Rizvi fashions Ltd.

Anwar Jang Road, 1 No. Kalma Bazar, Savar
(23.87805944N, 90.28969194E)

15th February 2015

Observations

Cracking above 1st Floor on the cantilever part and the entrance porch

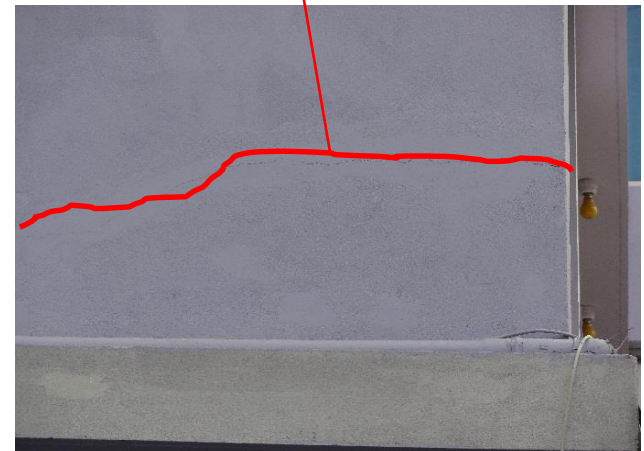
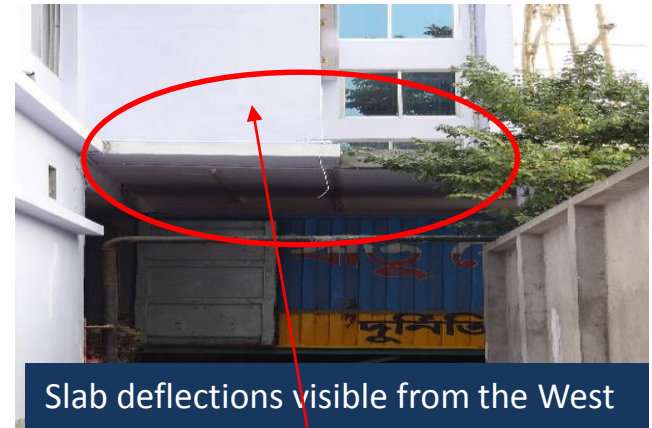
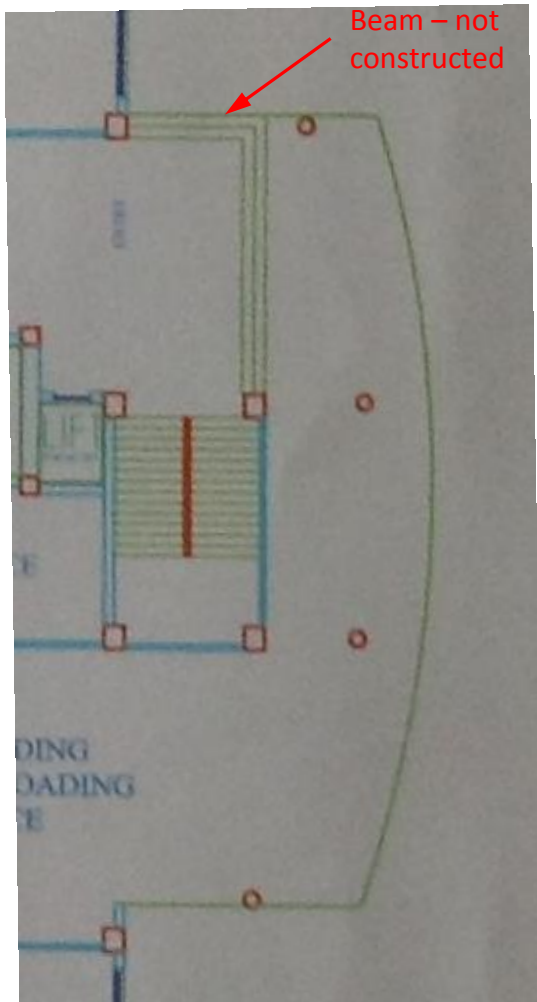
Possible deflection of first floor cantilever / canopy slab due to following works , causing cracking in supported external brickwork wall (red star).

Item No.	Observation	Recommended Action Plan	Recommended Timeline
1	Cracking to 1st floor level on the cantilever part and the entrance porch	An Engineering Assessment of the cantilever parts on the main entrance porch (east and west sides) of the Factory Building to be carried out.	6-weeks
2	Cracking to 1st floor level on the cantilever part and the entrance porch	Factory Engineer to review design, loads and slab stresses in the entering porch and cantilevers using a model based design check to loading set out in BNBC-2006.	6-weeks
3	Cracking to 1st floor level on the cantilever part and the entrance porch	Do not load the zones of the cantilever until the end of the Engineering Assessment.	6-weeks
4	Cracking to 1st floor level on the cantilever part and the entrance porch	Make structural alterations as advised by Engineer. Sections of plaster finish to be removed to investigate if cracks penetrate the building structure. Building Engineer to review further if cracks are found to penetrate into building structure.	6-months

5	Cracking to 1st floor level on the cantilever part and the entrance porch	Carry out repair remedial works as required.	6-months
6	Cracking to 1st floor level on the cantilever part and the entrance porch	Continue to monitor for cracking on an on-going basis.	6-months

Discrepancies between drawings and as-built details

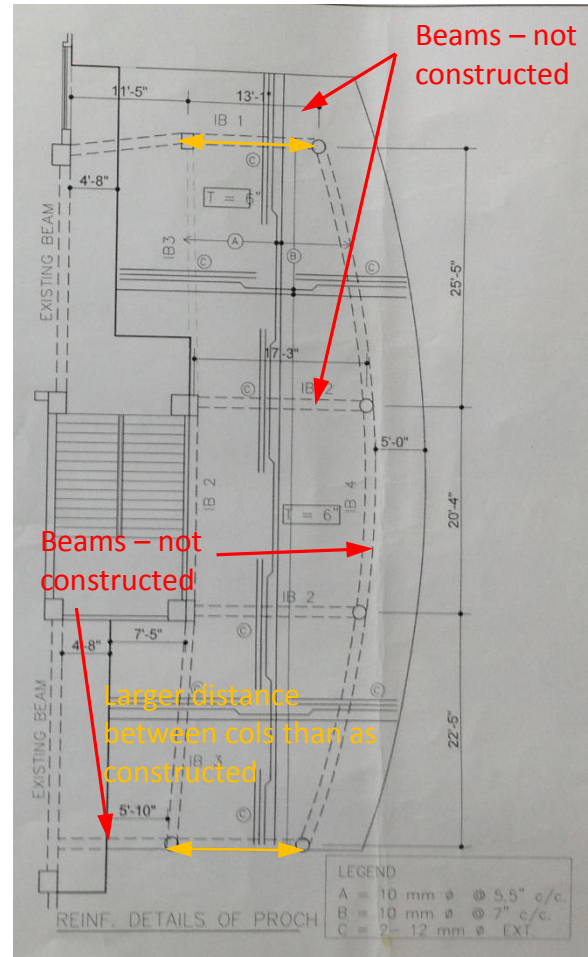
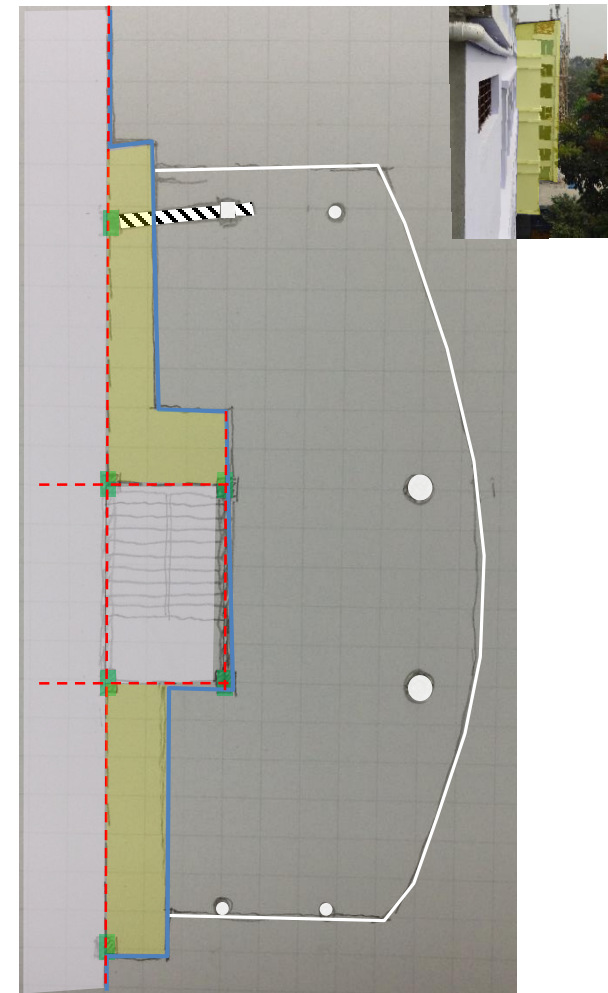
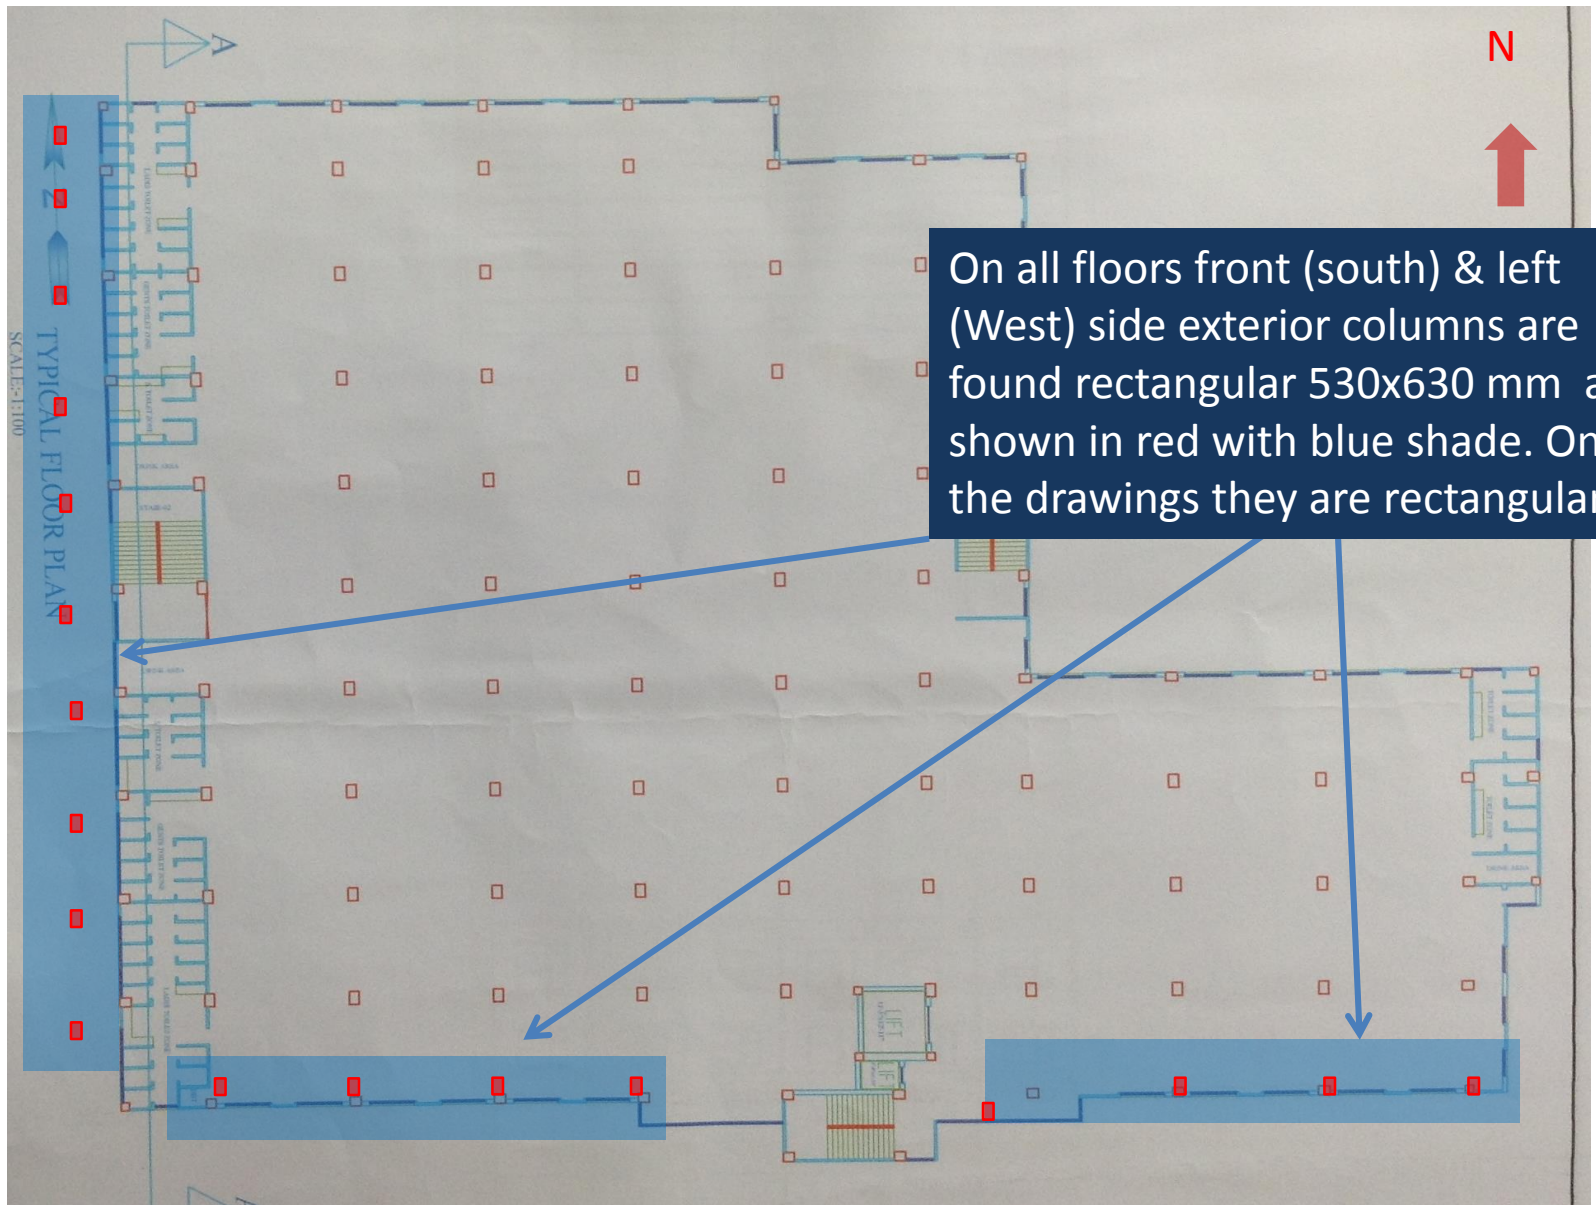
Canopy size and spans are reduced compared with design. However the canopy has been constructed at a flat slab with no beams.

Item No.	Observation	Recommended Action Plan	Recommended Timeline
7	Discrepancies between structural drawings and the as-constructed arrangement of the factory	Building engineer to survey as constructed building. Updated drawings to be prepared showing the correct as constructed layout.	6-months
8	Hairline cracking in the cantilevers	Sections of plaster finish to be removed to investigate if cracks penetrate the building structure. Building Engineer to review further if cracks are found to penetrate into building structure.	6-months
9	Hairline cracking in the cantilevers	Carry out repair remedial works as required.	6-months
10	Hairline cracking in the cantilevers	Continue to monitor for cracking on an on-going basis	6-months
11	Apparently non engineered stair case structures	Before construction the Building Engineer to check the capacity of the lightweight stairs and make any necessary alterations. The connections to the Utility building must also be precise.	6-months

Hairline cracking in the cantilever part

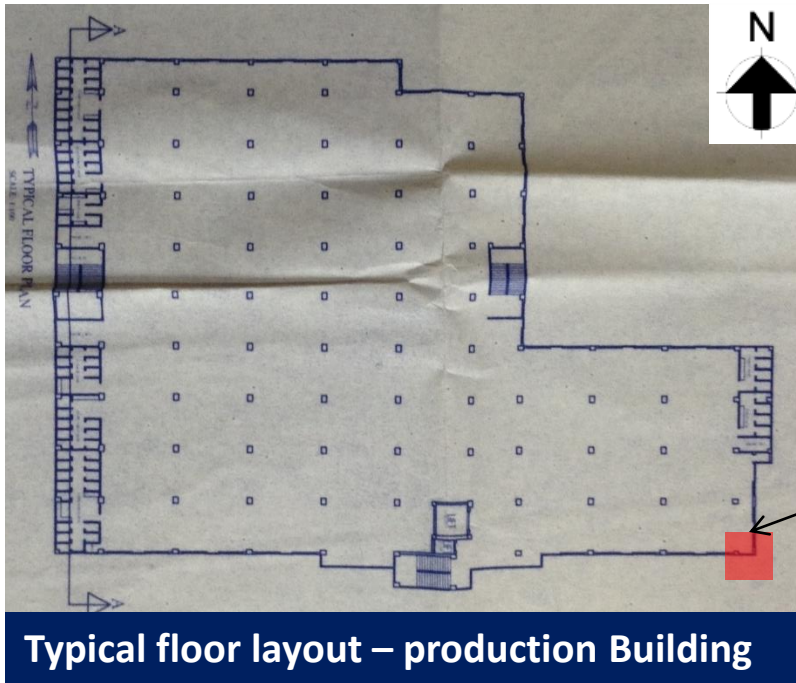
Hairline cracking in the cantilever part.

Apparently non engineering evacuation stairs on the Utility Building

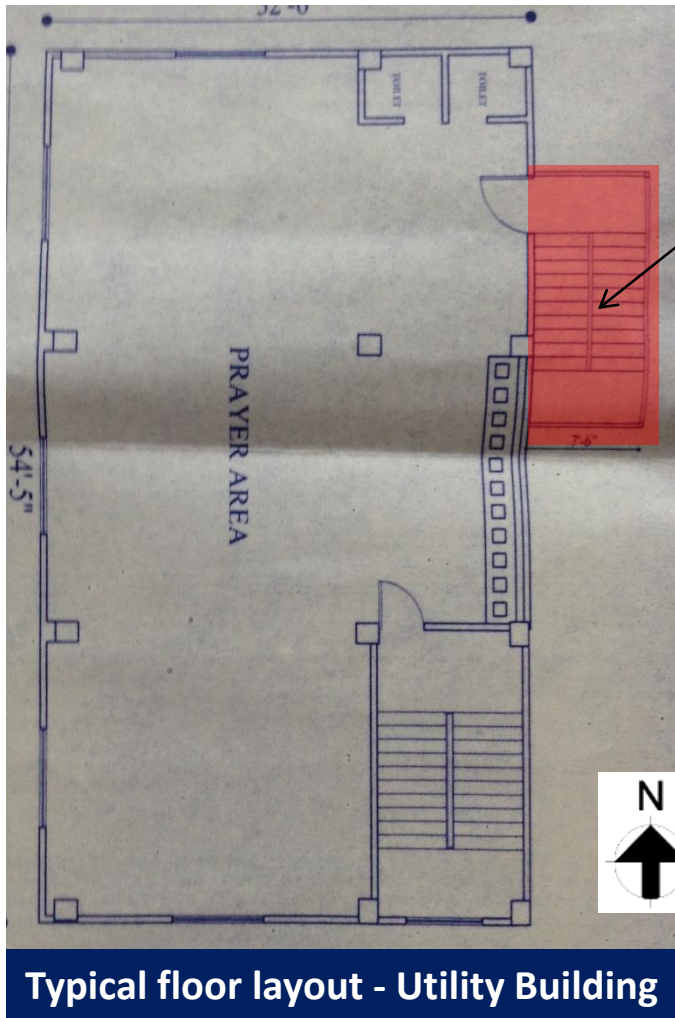
The evacuation stairs are not yet constructed, but they have plan to build it. This structure looks like a non engineering steel structure and there are no existing connection details.
